**DEPARTMENT OF PLANNING AND BUILDING
STAFF REPORT
TO CITY OF LAKE FOREST PARK HEARING EXAMINER**

City File Numbers: 2020-SSD-0002

Requested Action: Approval of Shoreline Substantial Development Permit to repair (6) piles, reconstruct the dock with updated thru-flow grated decking material, install a 18'x6' extension supported by (2) new 8' steel piles, install a 10'x16' platform lift, replace the existing bulkhead stairs with rock steps and repair the entire existing bulkhead. Re-locate existing boat lift with canopy from north of existing dock to the south side of the dock.

Site Location: 17727 Beach Drive NE
Lake Forest Park, WA 98155; Parcel # 4030100255

A5.0
SHEET

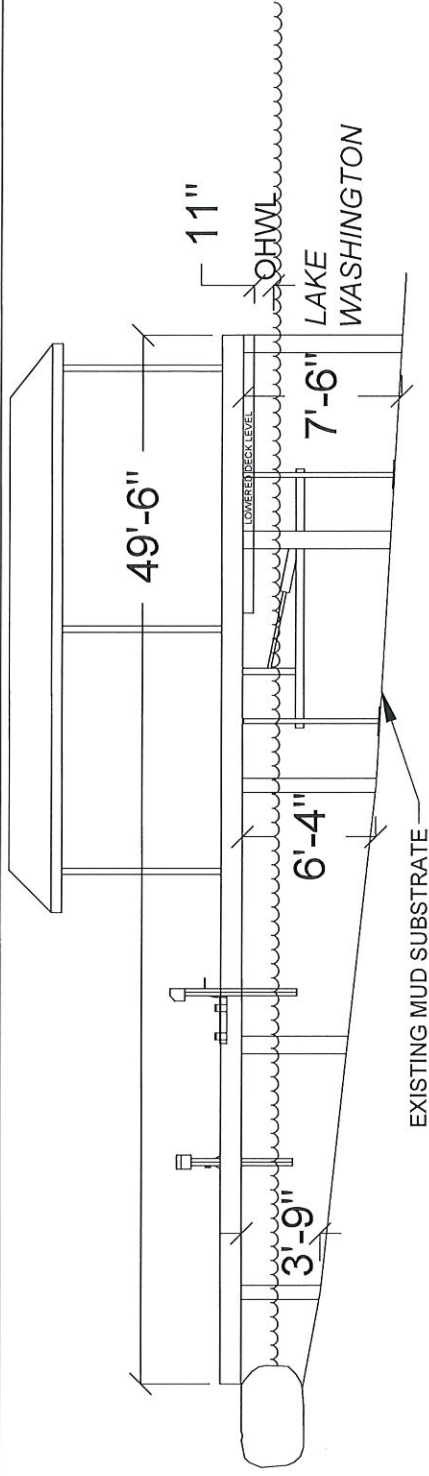
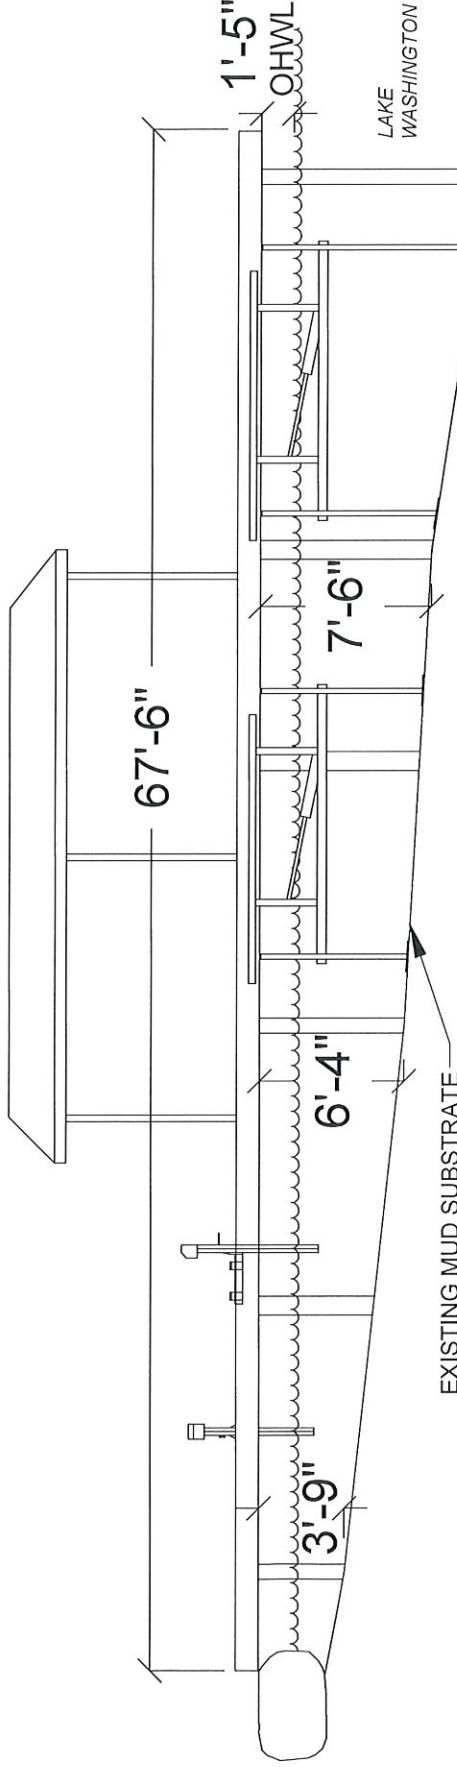
The submitted drawings indicate an existing distance of 1'1" between the OHWM and the top of the existing pier (Exhibit 6). Sheet A5.0 shows that the proposed distance between the OHWM and the top of the existing pier is planned to be 1'5". While information provided is conflicting,

The submitted drawings indicate an existing distance of 1'1" between the OHWM and the top of the existing pier (Exhibit 6). Sheet 5.0 shows that the proposed distance between the OHWM and the top of the existing pier is planned to be 1'5". The combined information provided suggests that the greatest distance that the proposed pier may have with the water body may reach a height as much as 2'

MITIGATION PLAN

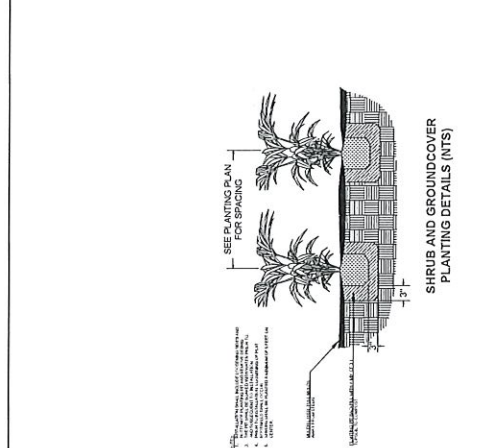
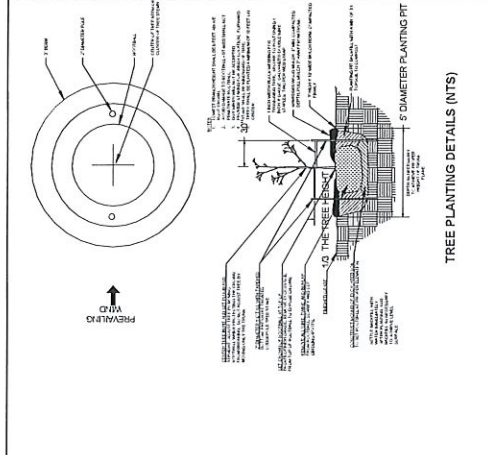
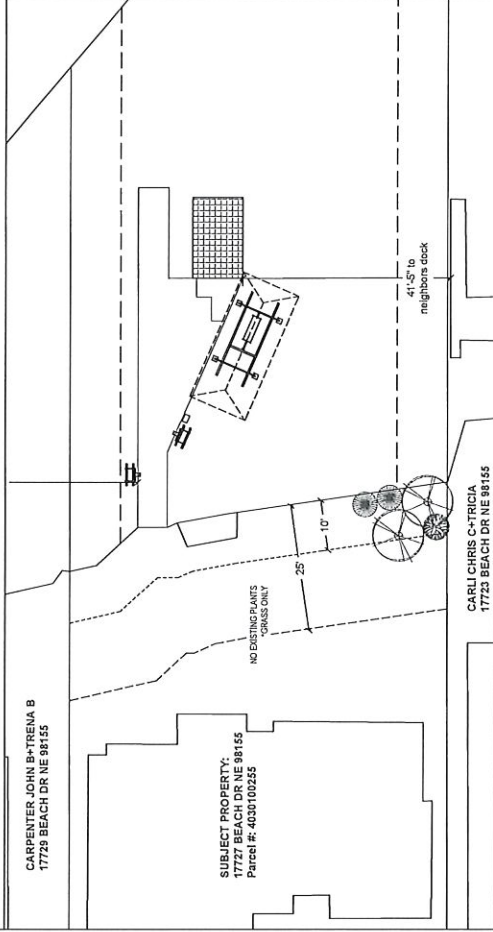
The site currently does not have any native vegetation planted within the shoreline area. The proposed design includes a mitigation plan that, with the recommended conditions, complies with the requirements for new piers. Specifically, the plan provides native riparian vegetation in at least 75 percent of the nearshore riparian area located along the water's edge. The vegetated portion of the nearshore riparian area averages ten (10) feet in depth from the OHWM. The proposed plantings consist of a mixture of native trees, shrubs and groundcover and will be designed to improve habitat functions along the shoreline environment. Specifically, the proposed planting plan includes two western red cedar trees, three nootka rose shrubs and three mock orange shrubs which is consistent with the required three trees per 100 linear feet of shoreline but falls significantly short of the required 60% (approximately 450 square feet) shrub density. A recommended condition will be for the permittee to provide an updated planting plan with their application for a building permit and demonstrate that the required 60% shrub density can be achieved, or, that the permittee provide an alternative planting plan or mitigation measure (as allowed in SMP 8.5 (B) (3) (h) (iv) (a)- mitigation requirements) in lieu of meeting the prescriptive requirements if it can be approved by other state and federal agencies.

In addition to the native planting plan, the permittee proposes to provide as-built drawings and photographs after installation of the mitigation plantings. The permittee also proposes annual monitoring reports for 5 years that include written and photographic documentation on tree and shrub mortality. The following performance standards for the mitigation are recommended for the mitigation:

- One-hundred (100) percent survival of all planted native trees and shrubs during the first two (2) years after planting; and
- One hundred (100) percent survival of trees and eighty (80) percent survival of remaining native plants in years three (3) through five (5).

To ensure performance standards are met, and to ensure plantings survive, staff recommends that a financial security be posted for a maintenance period of five years. The cost of the financial security shall be based on the fair market value of labor and materials for the planting installation.

13. The Permittee shall provide an updated mitigation planting plan with their application for a building permit and demonstrate that the required 60% shrub density can be achieved, or, the Permittee shall provide an alternative planting plan or mitigation measure in lieu of meeting the prescriptive requirements if that plan can be approved by other applicable regulating state and federal agencies. The following performance standards shall be applicable for the mitigation planting:
